Review of two flood mitigation projects: Bragg Creek / Springbank off-stream flood storage and McLean Creek flood storage

<b>Date</b>	<b>Our reference</b>	<b>Number of pages</b>
October 7, 2015	1220924-001-BGS-0001-lk	8
<b>From</b>	<b>Direct line</b>	<b>E-mail</b>
Hans van Duijne	+31(0)88335 7776	hans.vanduijne@deltares.nl

Review of two flood mitigation projects: Bragg Creek / Springbank off-stream flood storage and McLean Creek flood storage

Figure 1 Location and reservoir area of the Elbow River Dam at McLean Creek (MCI)

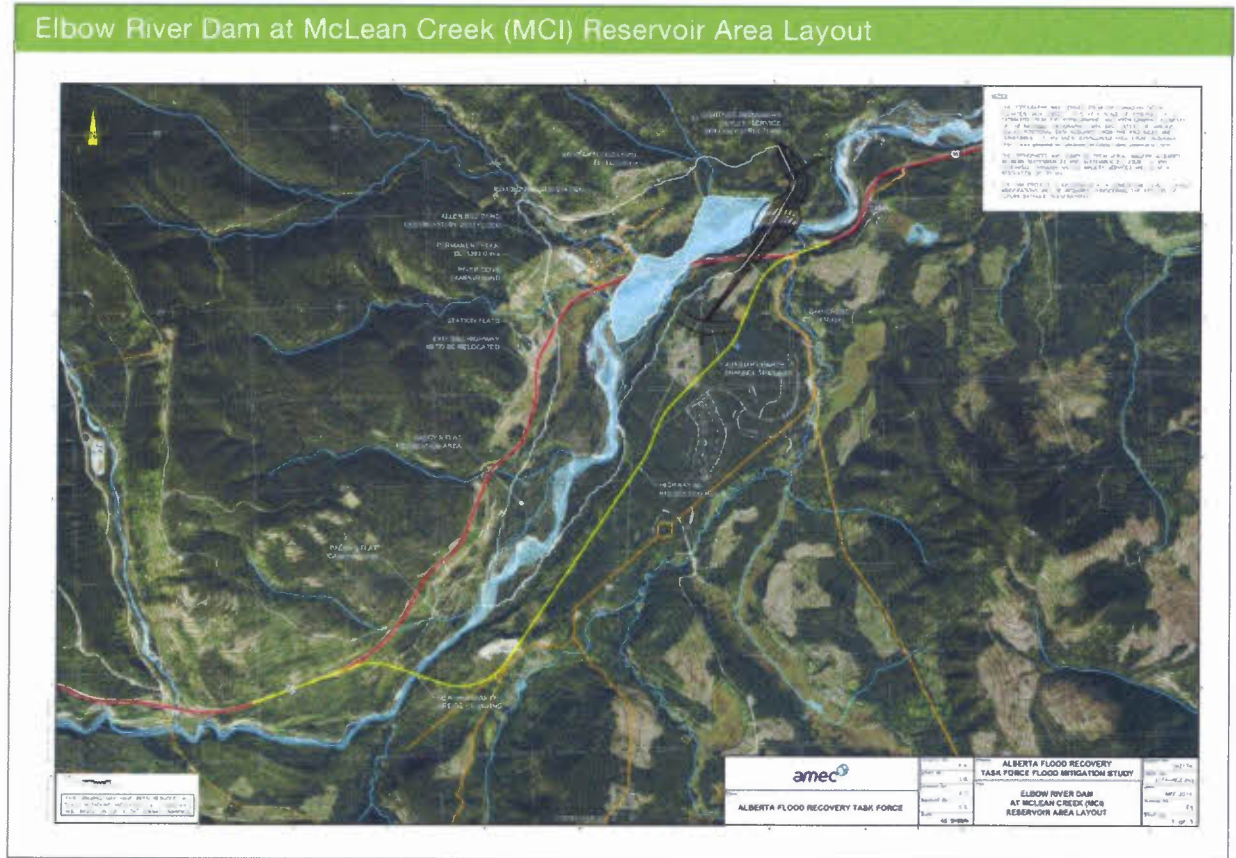
As described by AMEC (2014a), this project involves building an earth-fill dam across the main stem of the Elbow River. The proposed earth-fill dam (main embankment) traverses a river gorge, which is approximately 110 m wide at the base and is steep walled for a height of about 28 m (maximum height 50m). The dam includes a combined concrete outlet/service spillway structure for discharging normal and flood flows, and includes an auxiliary earth cut channel spillway to protect the dam from extreme floods up to the Probable Maximum Flood (PMF) event. The permanent outlet/service spillway is a gated conduit structure with its intake invert located about 21 m above the valley bottom. The concrete gates would typically be left in a wide-open position thereby allowing free passage of river water with minimum rise of the reservoir level during normal flow conditions (i.e., non-flood). The gates would be strategically closed during flood events thereby holding back a significant portion of the flow in reservoir storage. The concrete structure also serves as an emergency spillway designed to let above-design floods pass, thereby protecting the dam from potential overtopping or overloading and associated catastrophic failure.

The conceptual design includes a small permanent pool in the valley bottom, permanently containing approximately 4,000 dam<sup>3</sup> of water as dead storage. This storage should prevent incoming larger bottom sediment from plugging the intake area. There is no low level outlet to release the dead storage. Additional water could be contained above the dead storage El. 1,398.0 m (i.e., multi-use storage) by regulating the permanent outlet gates. The potential benefit and/or need for multi-use storage at this site has not yet been reported.

Figure 2 Location and reservoir area of the Springbank off-stream storage project (SR1)

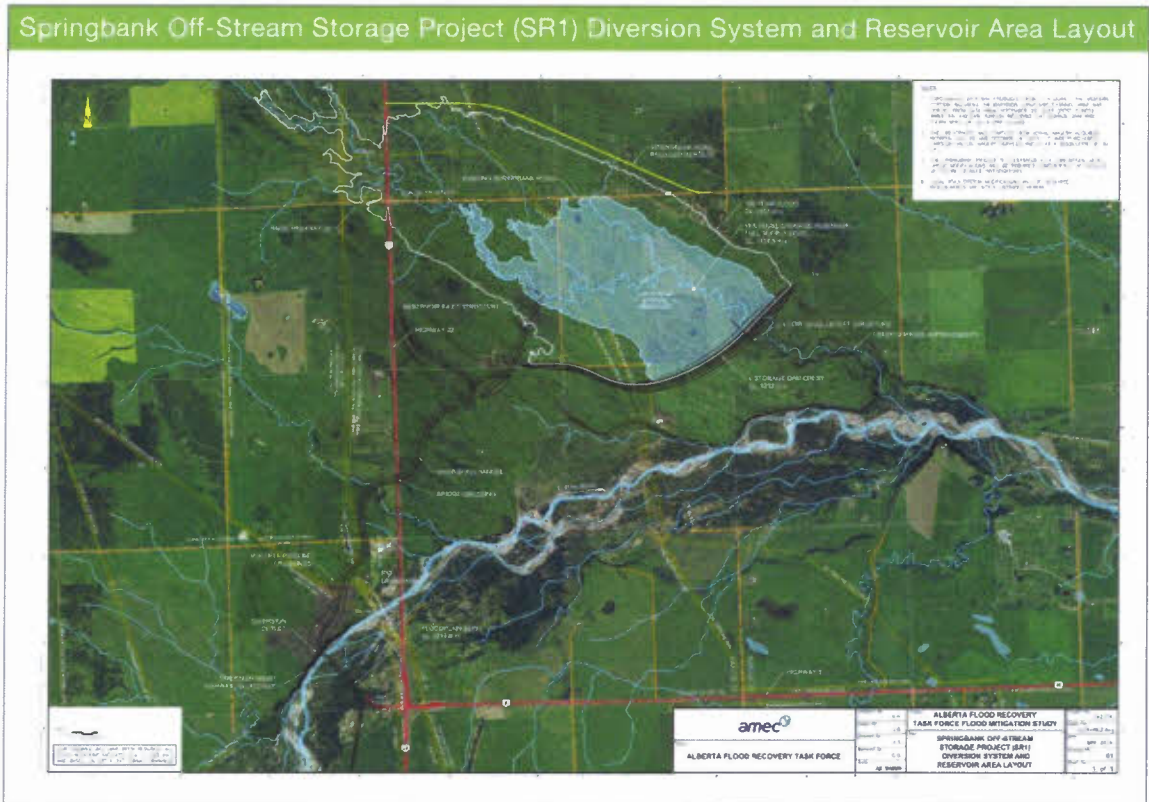
The Springbank off-stream storage (SR1) site is located just west of Calgary approximately 18.5 km upstream of the Glenmore Reservoir in a relatively undeveloped farmland and ranchland valley. According to the concept prepared by AMEC (2014b), the SR1 concept involves diverting extreme flood flow from the Elbow River into an off-stream storage reservoir where it would be temporarily contained and later released back into the Elbow River after the flood peak has passed.

<sup>1</sup> In the Stantec adjusted design (April 2015) this seems to be removed, only a 40 m wide spillway/sluiceway in the river bed is assumed. Also Stantec adjusted the diversion channel capacity to 600 m<sup>3</sup>/s, with design 6.4 m water depth. Also the storage dam is a bit higher and a few 100 m downstream. Same intake location from the river, and same outlet structure at the dam
